Subject: ISSUANCE OF AMENDMENT NO. 49 TO FACILITY OPERATING LICENSE NPF-21 -  
WPPS NUCLEAR PROJECT NO. 2 (TAC NO 59798)

This amendment revises WNP-2 Technical Specifications Section 6.4.1 and the organization charts in Figures 6.2.2-1a and 6.2.2-1b to reflect organizational and other administrative changes at WNP 2.

Amendment No. 49  
License No. NPF-21

SAFETY EVALUATION BY THE OFFICE OF NUCLEAR REACTOR REGULATION  
SUPPORTING AMENDMENT NO. 49 TO FACILITY OPERATING LICENSE NO. NPF-21  
WASHINGTON PUBLIC POWER SUPPLY SYSTEM  
WPPS NUCLEAR PROJECT NO. 2  
DOCKET NO. 50-397

FIGURE 6.2.2-1a  
UNIT ORGANIZATION

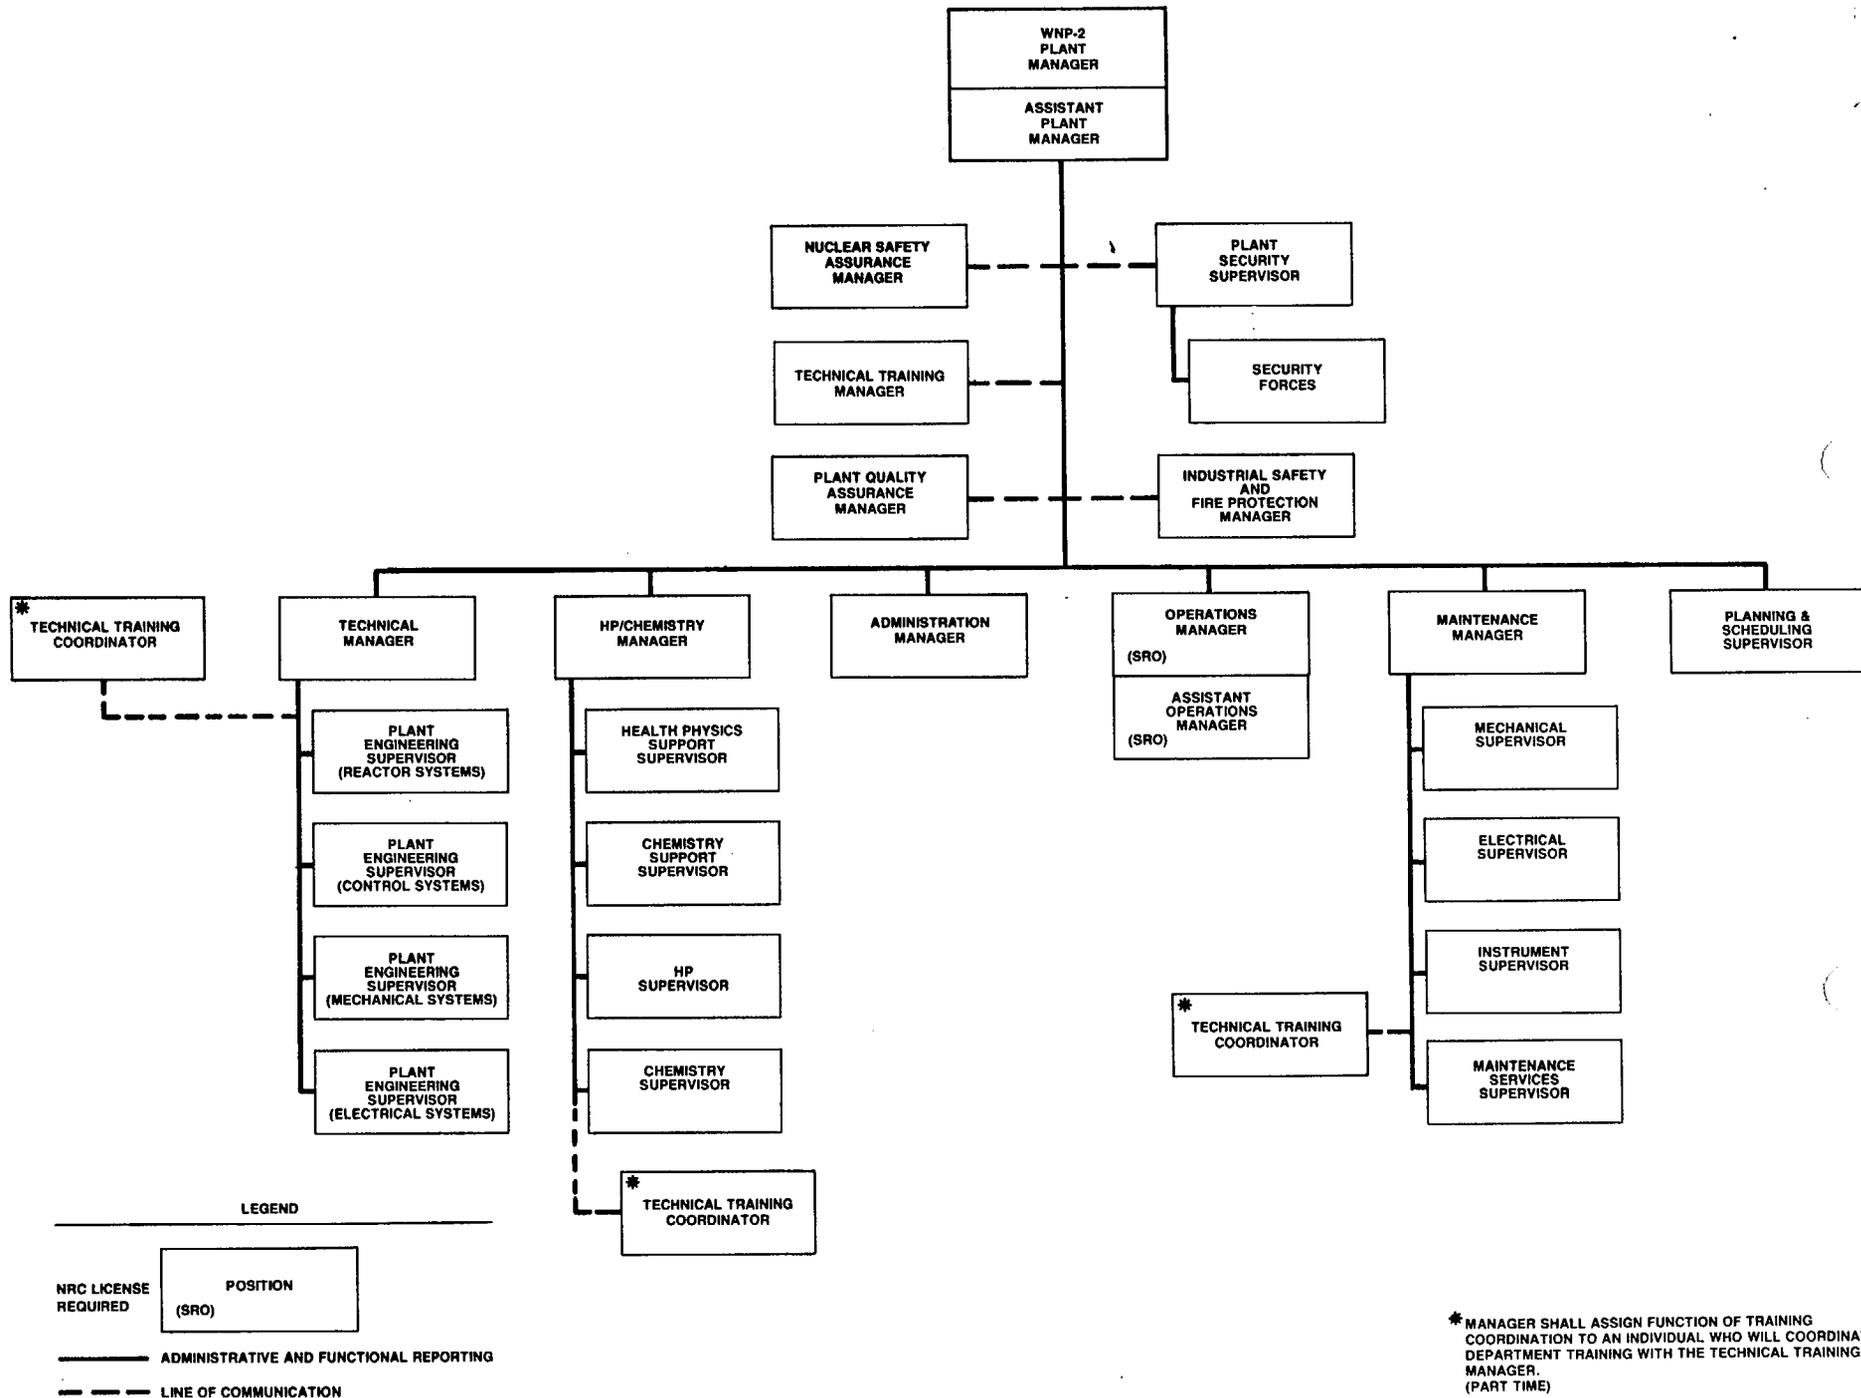
Washington Public Power Supply System has requested, by letter dated September 27, 1985, and clarified by letters dated November 6, 1985 and September 17, 1986 changes to the Administrative Controls section of the Technical Specifications for Nuclear Plant Number 2. These proposed changes would revise the Unit Organization and alter the responsibility for the plant training program. The organization charts are shown in Figures 6.2.2-1a and 6.2.2-1b of the Technical Specifications.

- The title "Industrial Safety Supervisor" has been changed to "Industrial Safety and Fire Protection Manager."
- The title "Reactor Engineering Supervisor" has been changed to "Plant Engineering Supervisor (Reactor Systems)."
- The title "Plant Engineering Supervisor" has been changed to "Plant Engineering Supervisor (Control Systems)."
- The title "Plant Engineering Supervisor" has been changed to "Plant Engineering Supervisor (Mechanical Systems)."
- The title "Health Physics Chemistry Support Supervisor" has been changed to "Health Physics Support Supervisor." The Chemistry Support function has been transferred to the new position of Chemistry Support Supervisor.

- Chemistry Support Supervisor - This function was formerly performed by the Health Physics Chemistry Support Supervisor.

- ° Plant Engineering Supervisor (Electrical Systems) - This function was formerly performed by a Plant Engineering Supervisor who had responsibility for both control systems and electrical systems.
- ° Assistant Operations Manager - This position was created to provide assistance to the Operations Manager.

- ° The position of Procurement Manager that reported to the Maintenance Manager now reports to the Manager Operations Controls and Material.
- ° The function of the position of Planning/Scheduler that reported to the Maintenance Manager has now been transferred to the Planning and Scheduling Supervisor who reports to the Plant Manager.
- ° The responsibility for the retraining and replacement training has been assigned to the Technical Training Manager. Each plant staff department manager shall assign the function of training coordinator to the individual who will coordinate the department training with the Technical Training Manager.
